APC 224  
Brunswick, Me.  
Hydro

April 7, 1977 Meeting with CDFG and Maine Fishery Agencies  
regarding proposed fishway at CDFG Brunswick Project on  
Androscoggin River - Brunswick, Maine

PROPOSED FISHWAY

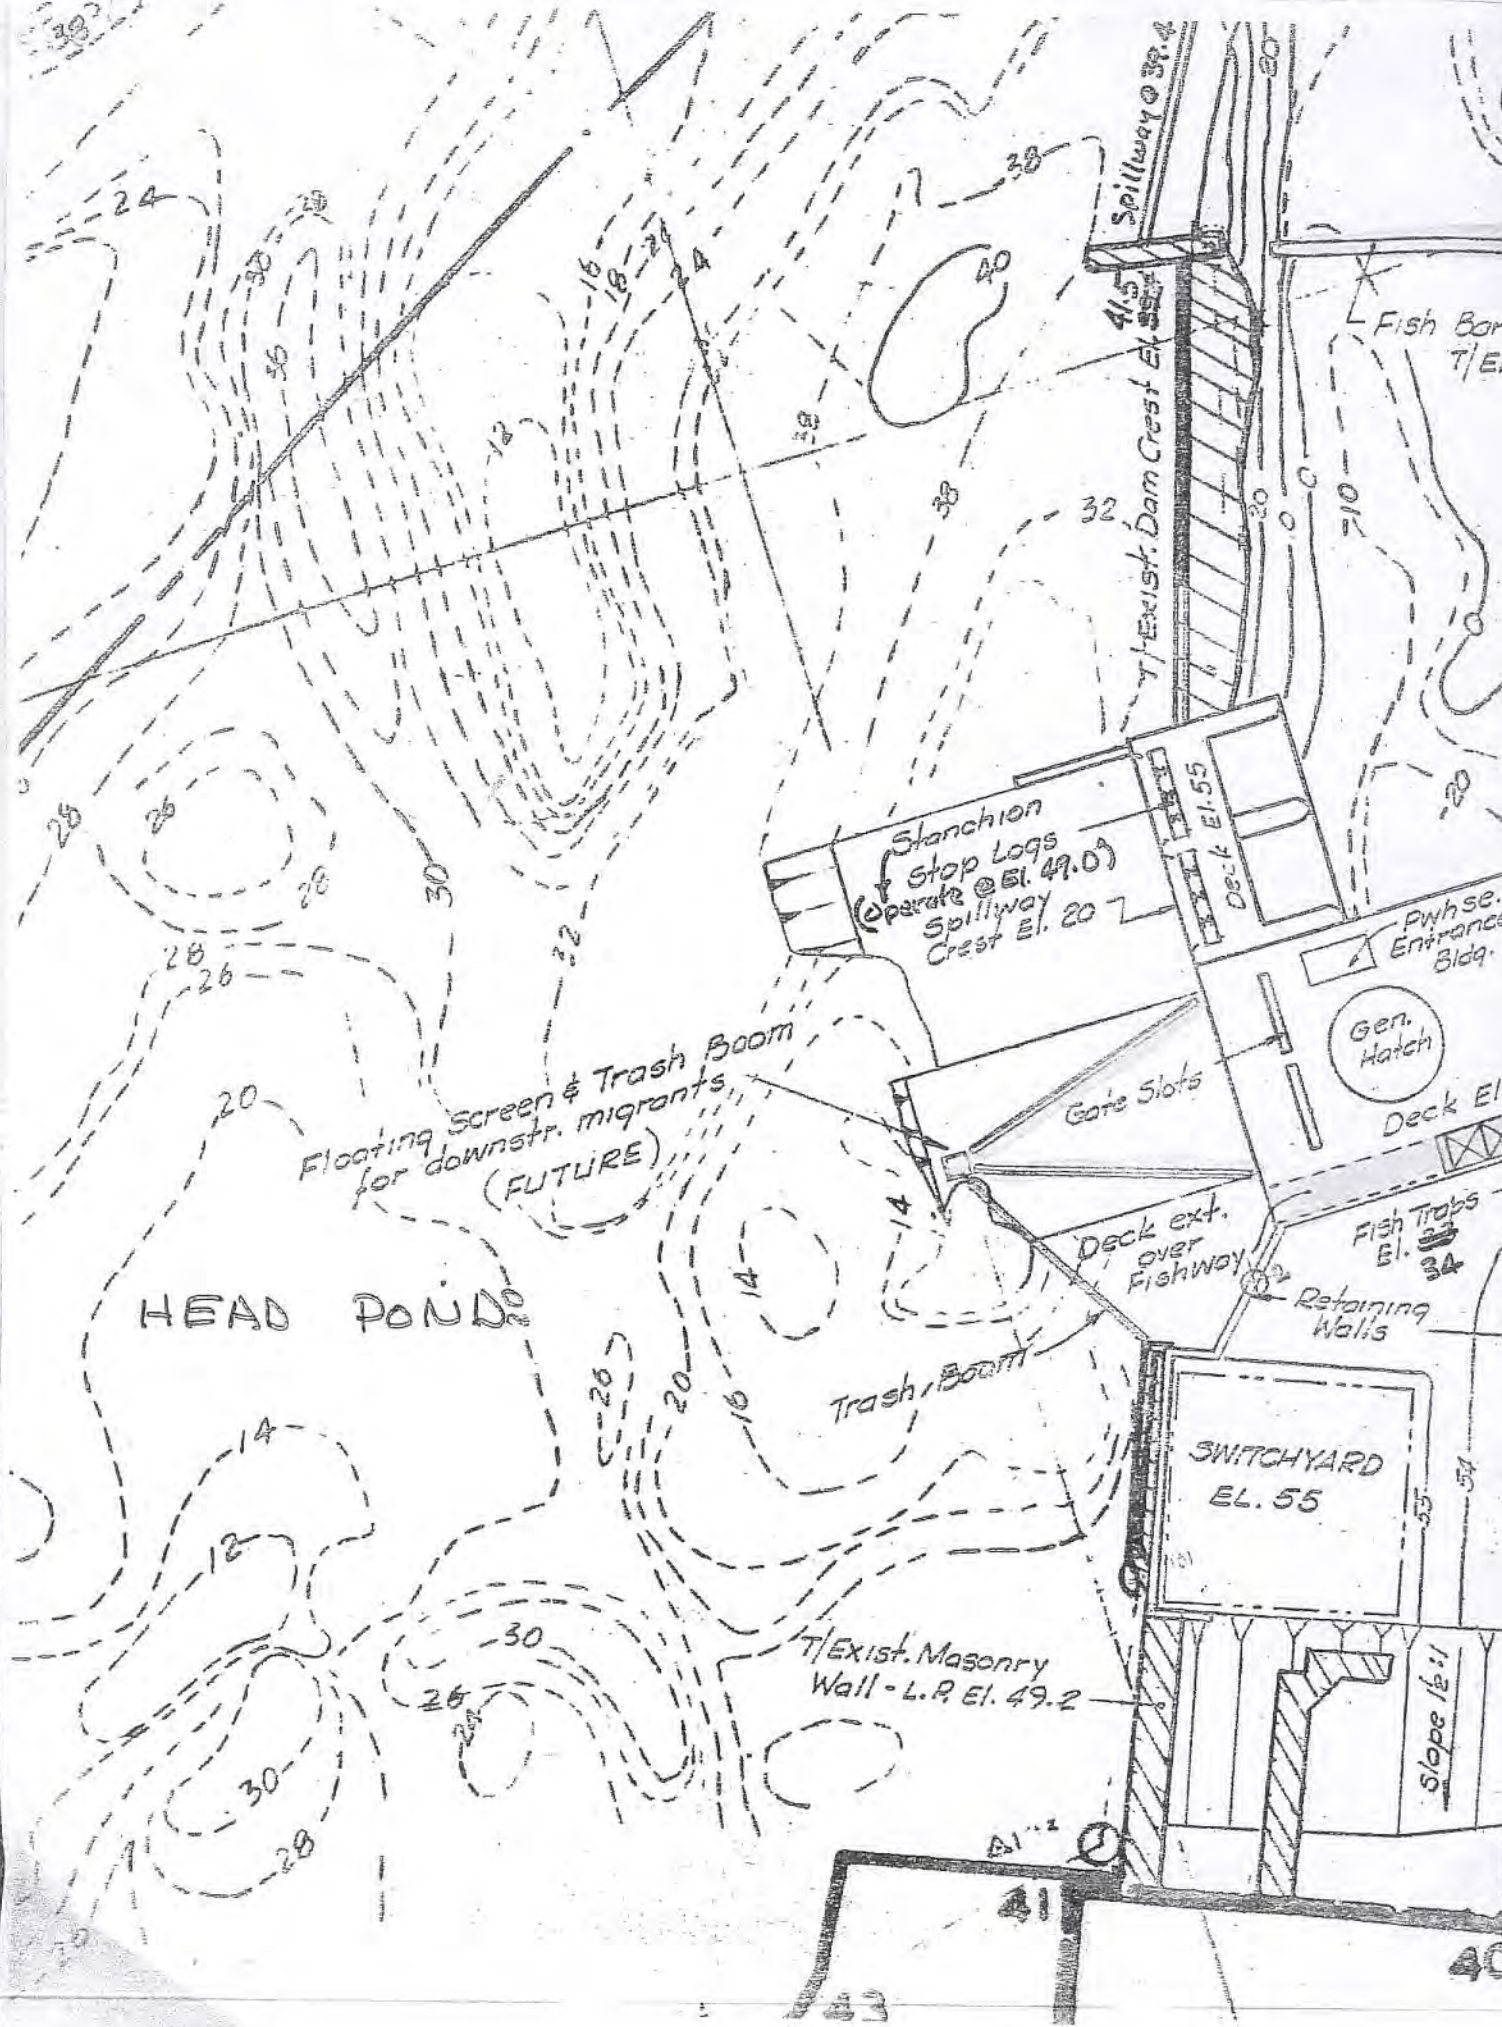
1. A vertical-slot type fishway constructed adjacent to  
the proposed powerhouse. (8'-0" wide x 10' long fish-  
way with 1/2" x 2" slots). The fishway is designed to  
pass a run of 25,000 American eel and 1 million  
smelt.
2. A side-slope fish counting and trapping facility is  
included at the upstream end of the fishway. This  
facility can trap fish species selectively, or trap  
the entire run.
3. An attraction water will be piped from the head-  
pond through flow diffusion chambers into the fishway,  
where it combines with the 30 cfs + flowing through the  
fishway to provide a total of 100 cfs + attraction  
water at the fishway entrance.

4. The existing timber crib spillway under the House 201 bridge will be lowered approximately 4' to crest elevation 14. This structure will serve as a fish barrier dam to keep upstream migrants from entering the spillway area during periods of spillway discharge. A fish barrier wall at crest elevation 20 is also required between the main spillway and the powerhouse.
5. A floating downstream migrant fish-screen and trash boom are also provided at the powerhouse intake for future installation if turbine mortality studies deem it necessary.
6. The fishway will operate for river flows up to 30,000 cfs. When flows exceed 30,000 cfs, a sluice gate, located at the fishway exit, will automatically close. This gate will open again when river flows fall below 30,000 cfs.

Lynn Bond's main concern was the introduction of carp and other rough fish to upstream habitat via spillways. To control the rough fish problem, the Department of Marine Fisheries agreed to trap and sort these fish at the fishway. This will involve considerable man-power and fish handling.

The State Fishery Agencies gave their informal concurrence with the proposed fish passage facilities. They indicated formal written approval would be forwarded to CDFCO upon receipt of a written request.
